## **Chapter 12 Discussion Topics List**

### **Chapter 12 Radiation Protection, RAIs 8254, 8275, 8353, 8247, 8098, and 8389 Conference Call with KHNP on APR1400 Design Certification Wednesday, May 18<sup>th</sup>, 2016, 7:00 p.m. – 9:00 p.m. (EST)**

Figure 12.3-17 Radiation Zones (Normal) Turbine Building El. 73'-0"

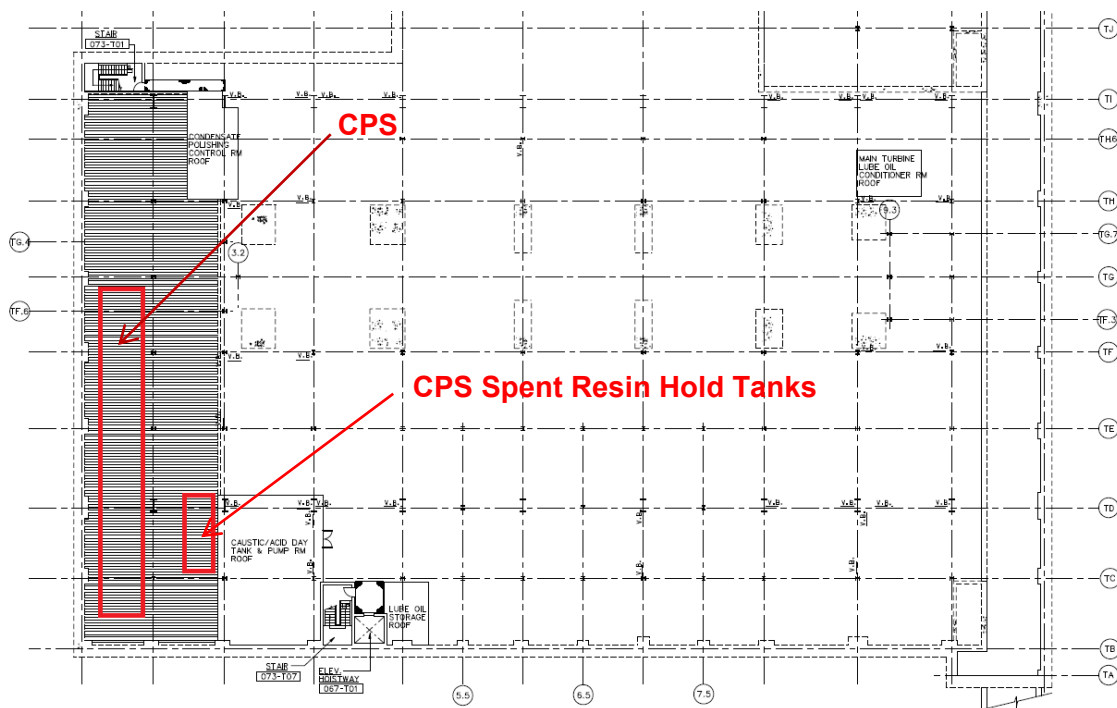
(NRC Status) Also, this was not discussed during the call but the CPS demineralizers and spent resin holding tank area do not appear to be identified in the Chapter 12 radiation zone maps for the Turbine Building. The DCD should be updated to identify and zone these areas properly in the DCD Chapter 12 figures. The response to Question 12.02-15 should be updated to include this information. (RP)

(KHNP Response) Radiation zone maps for Turbine Building are provided in DCD Figures 12.3-17 and 12.3-18. As shown below, the radiation zone at EL. 73'-0" is designated as Zone 2 and this area contains CPS demineralizers and the spent resin hold tanks. Shielding is provided around this area. Since no description is provided in Figure 12.3-17, KHNP will update this figure to include that this area contains CPS demineralizers and the spent resin hold tanks as a revised response to RAI 141-8098 Question 12.03-8.

Figure 10.4.10-1 (Sheet 3 of 3) will be revised as shown below:

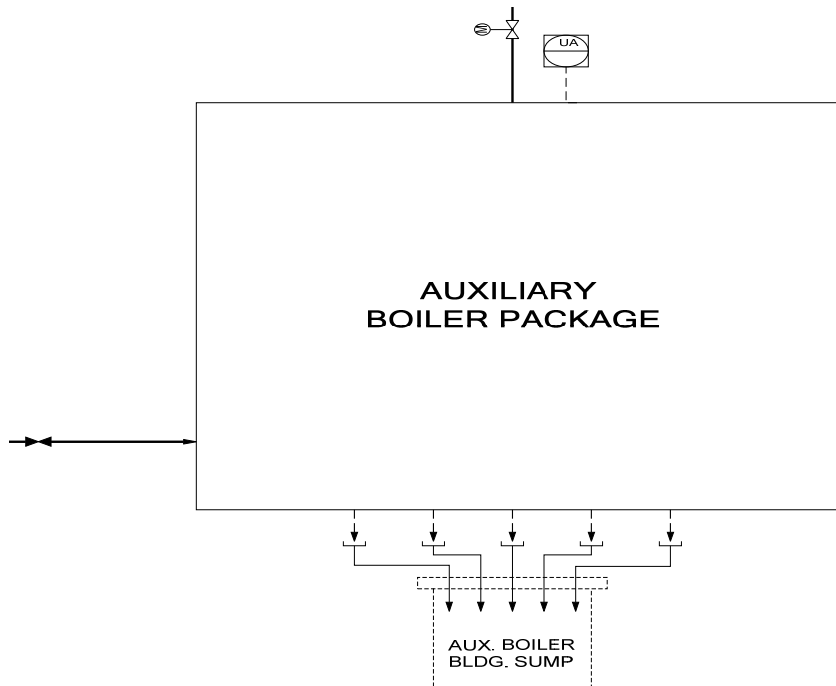
- a) First, it appears that monitoring for potentially radioactive fluid in the Auxiliary Steam System occurs prior to the fluid reaching the Auxiliary Boiler Package (apparently this is done by monitor RE-103, according to DCD Table 11.5-2) and if the system contains radioactive fluid, it is routed to the radwaste system prior to entering the Auxiliary Boiler Package. See Figure 10.4.10-1 (Sheet 2 of 3), which shows monitoring of the Auxiliary Steam System after the condensate receiver tank and an optional line to the liquid radwaste system prior to reaching the Auxiliary Boiler Package on Sheet 3 of 3. Therefore, it is unclear if the Auxiliary Boiler Blowdown would be expected to potentially contain radioactivity levels requiring treatment. More importantly, it is also unclear that the description of the blowdown drains in the DCD is accurate and that it will actually connect to the Liquid Waste Management system. While the response to RAI 8321, Question 09.02.02-9, adds a COL item specifying that the COL applicant is to provide the flow diagram of the turbine generator building drain system and the CCW heat exchanger building drain system, DCD Section 9.3.3.2.6 already indicates where the lines run. It states:

The above language implies that the design will include lines from the Auxiliary Boiler Blowdown to the sumps and apparently interconnecting the different sumps in the Turbine Building. Is this information in the DCD accurate? (ME)

Therefore, the auxiliary boiler blowdown would be expected to potentially contain radioactivity levels requiring treatment, and DCD Section 10.4.10.2.3 will be added as shown below and Figure 10.4.10-1 (Sheet 3 of 3) will be revised as shown below sketch diagram. KHNP will revise the response to RAI 8326, Question 09.03.03-4.

“The auxiliary boiler blowdown and drains are routed to the Auxiliary Boiler Building Sump and then are routed to the TGB sump for radiation monitoring. When contamination level of the drains is detected exceeding a predetermined setpoint, they are routed to the LWMS for processing and release via the condensate polishing area sump.”
